From: Edward Ledwidge [REDACTED]
Sent: 27 May 2015 11:46
To: Agency Dan McEwan
Subject: RE: Land South of New Road - A/23/15/OUT

Road Safety Audit Report

Incorporating
Stage 1 Completion of Preliminary Design.

Proposed Access off the A259 New Road, Rustlington

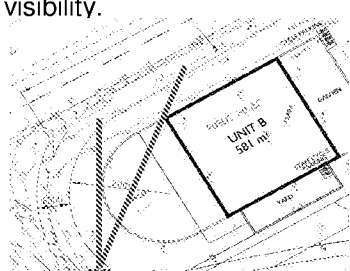
Audit Item No.	Audit Team Observation	Audit Team Recommendation	Designer / Scheme Response
A.3	JUNCTIONS		
A.3.1	PROBLEM Forward visibility to the roundabout is restricted Accident Type Shunt type accidents Location Roundabout Forward visibility to the give-way road marking at the roundabout from the deceleration lane is restricted to approximately 50 metres based on the building line of the adjacent pub/restaurant. This could be further restricted should a fence be erected around the associated grounds and could result in shunt type accidents where vehicles are stopped at the give-way.	Warning signs should be installed to ensure that approaching vehicles are aware of the presence of the roundabout and the pub/restaurant should be restricted from erecting a fence where it blocks forward visibility. 	Forward visibility to the site roundabout is restricted due to a boundary wall proposed around the public house garden area. The achievable forward visibility envelope is shown on Drg.No. REDW-REDW-3167-110-Rev A. An advanced warning sign of roundabout ahead (Diag. 510) and REDUCE SPEED NOW supplementary sign (Diag. 511) and SLOW road marking is proposed in advance of the roundabout which will mitigate the reduced forward visibility to the roundabout give way

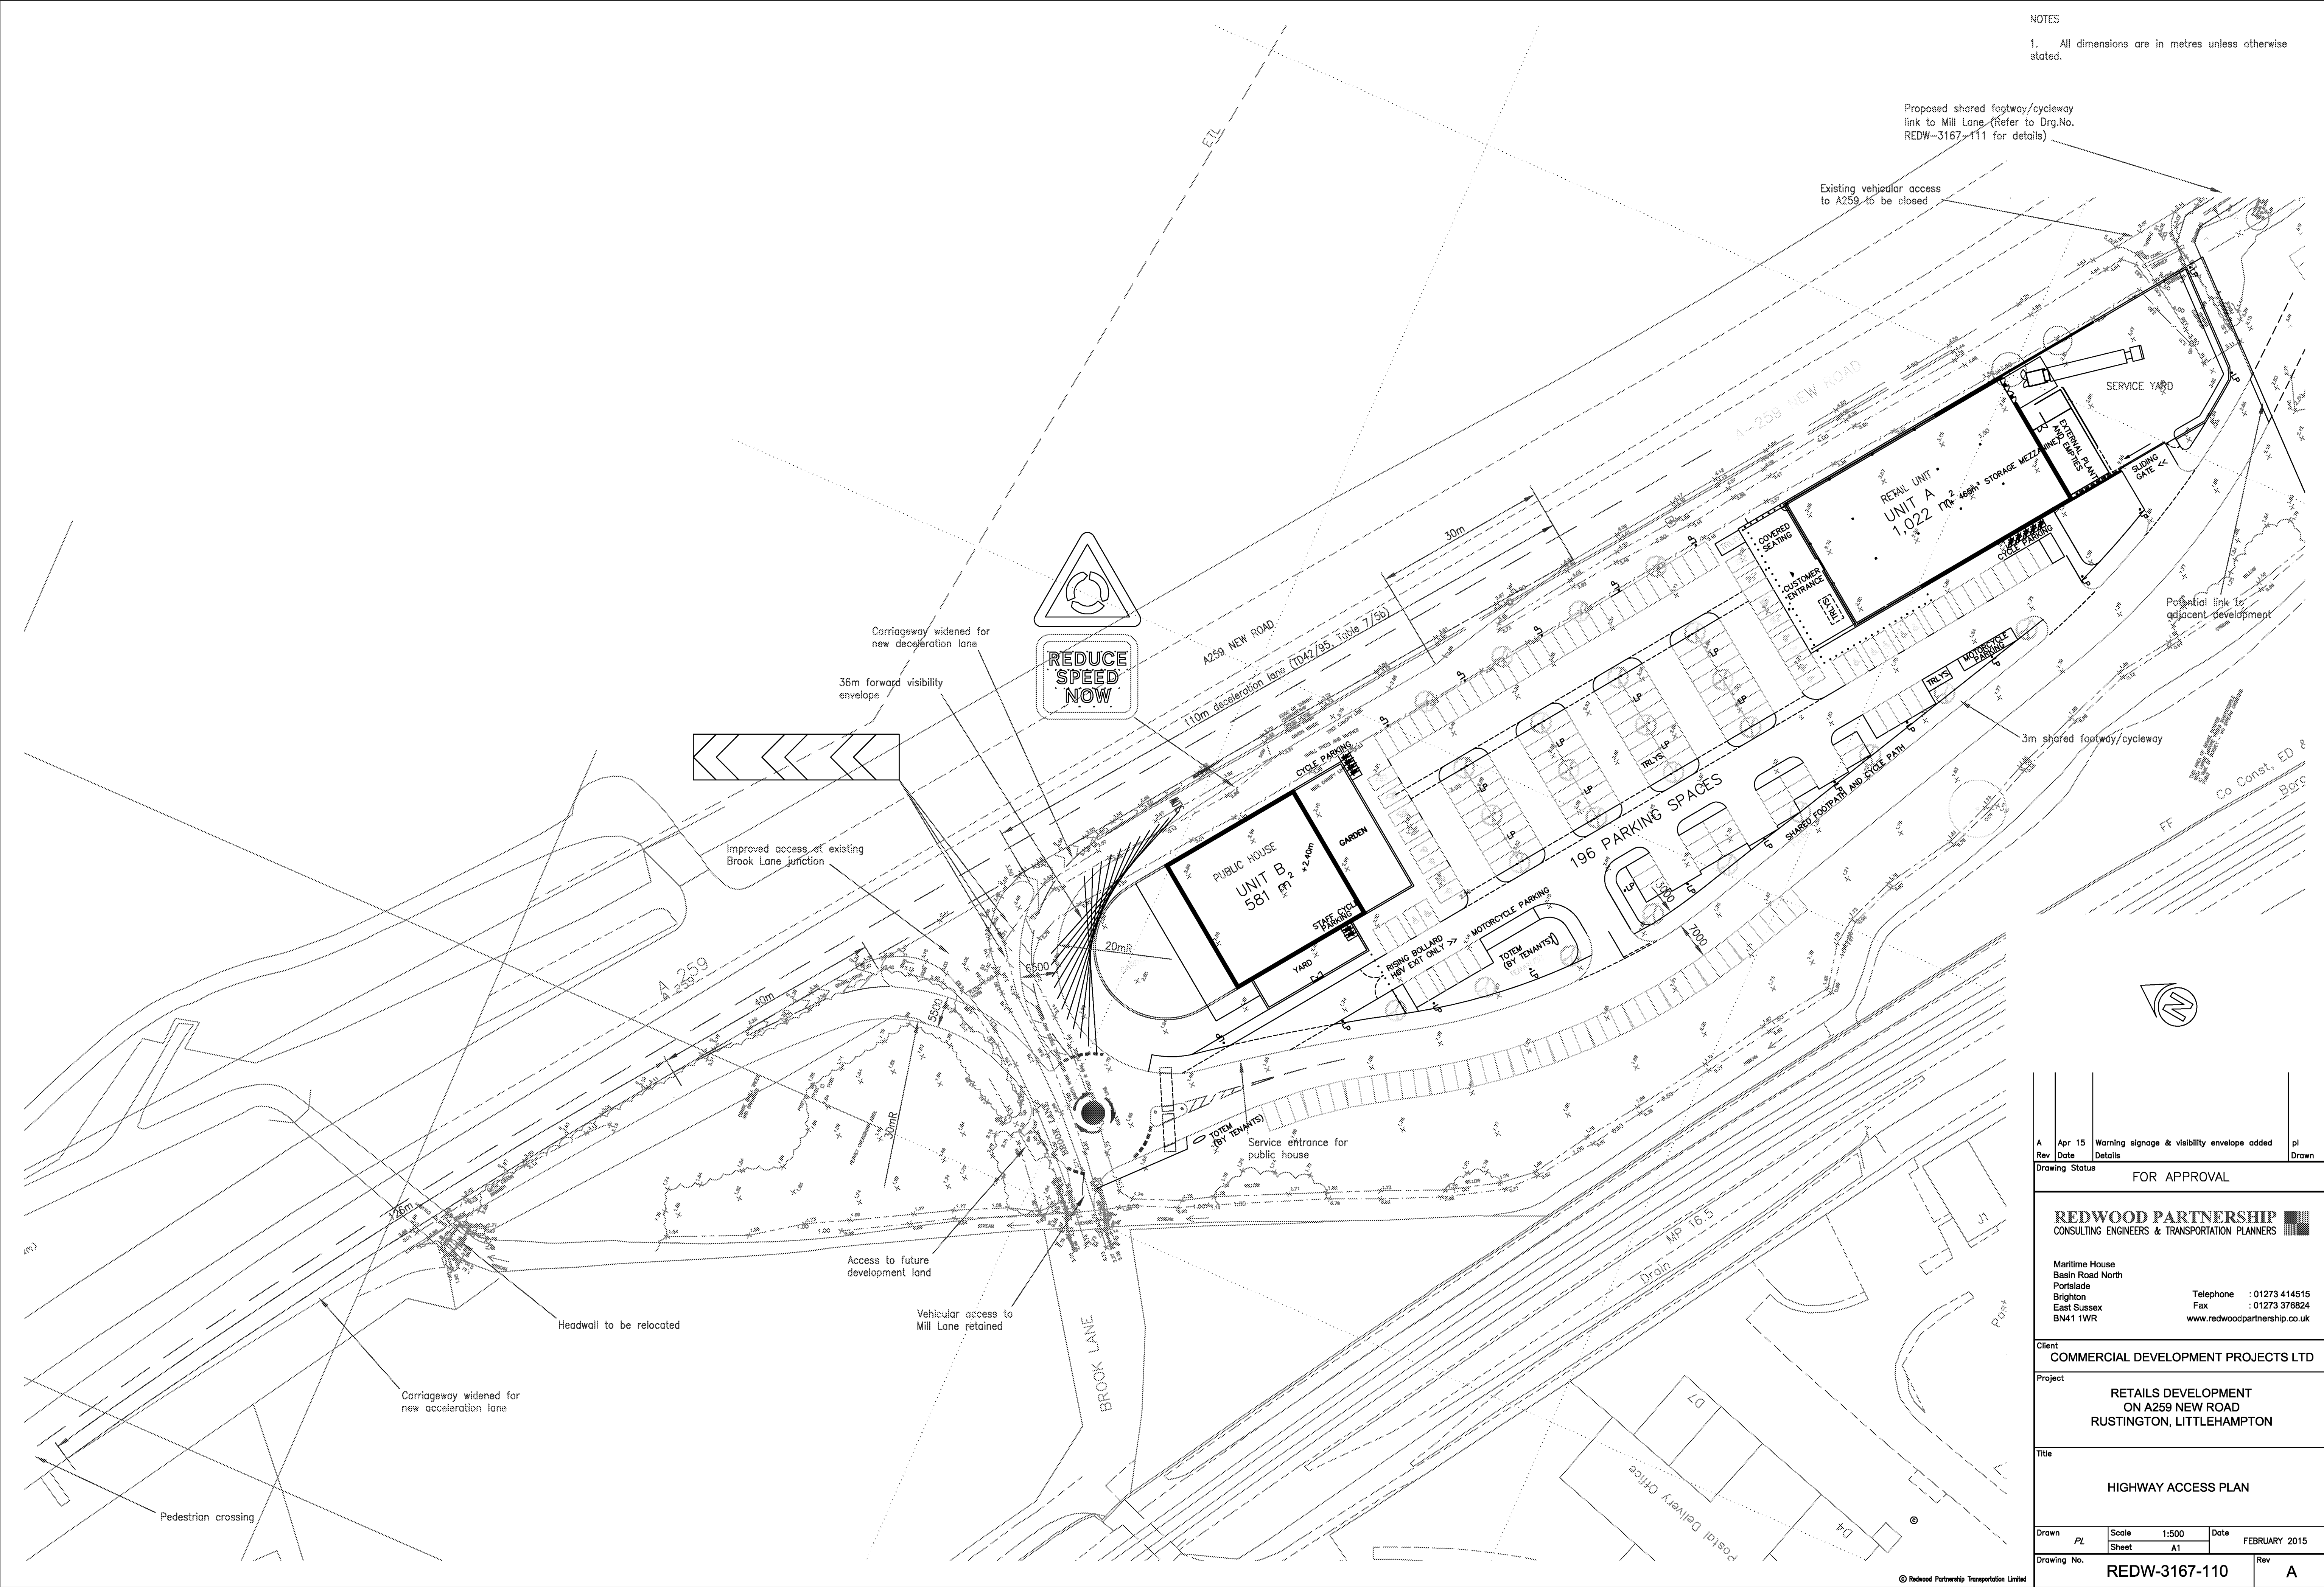
Audit Item No.	Audit Team Observation	Audit Team Recommendation	Designer / Scheme Response
A.1	GENERAL		
A.1.1	<i>The proposals to improve an existing access off the A259, New Road to facilitate the safe access and egress to / from a proposed development consisting of a food retail store and pub/restaurant at this location does not raise any road safety concerns in general at this stage, provided that the items raised within this audit in the following specific sections are addressed appropriately. The access road associated with the development is of sufficient length to allow for the free flow of vehicles off the A259 without the need to stop to allow vehicles to access and egress parking spaces.</i>		
A.2	LOCAL ALIGNMENT		
A.2.1	PROBLEM Tight entry corner radius Accident Type <i>Loss of Control</i> Location Entry radius from deceleration lane <i>The proposed deceleration lane is provided for vehicles to decelerate from the derestricted A259. Vehicles could therefore be travelling in excess of the speed required to safely manoeuvre around the 20 metre corner radius. This could result in vehicles losing control and striking the island.</i> The appropriate chevron and warning signs should be installed in clear view of vehicles utilising the deceleration lane to ensure that drivers are aware of the corner. Chevron sharp deviation of route signs (Diag. 515) have been included on the central approach island as shown on Drg.No. REDW-3167-110-Rev A

A	Apr 15	Warning signage & visibility envelope added	pl
Rev	Date	Details	Drawn
Drawing Status			
FOR APPROVAL			
REDWOOD PARTNERSHIP CONSULTING ENGINEERS & TRANSPORTATION PLANNERS			
Maritime House Basin Road North Portslade Brighton East Sussex BN41 1WR			
		Telephone : 01273 414515 Fax : 01273 376824 www.redwoodpartnership.co.uk	
Client COMMERCIAL DEVELOPMENT PROJECTS LTD			
Project RETAILS DEVELOPMENT ON A259 NEW ROAD RUSTINGTON, LITTLEHAMPTON			
Title HIGHWAY ACCESS PLAN			
Drawn	PL	Scale 1:500 Sheet A1	Date FEBRUARY 2015
Drawing No.	REDW-3167-110		Rev A
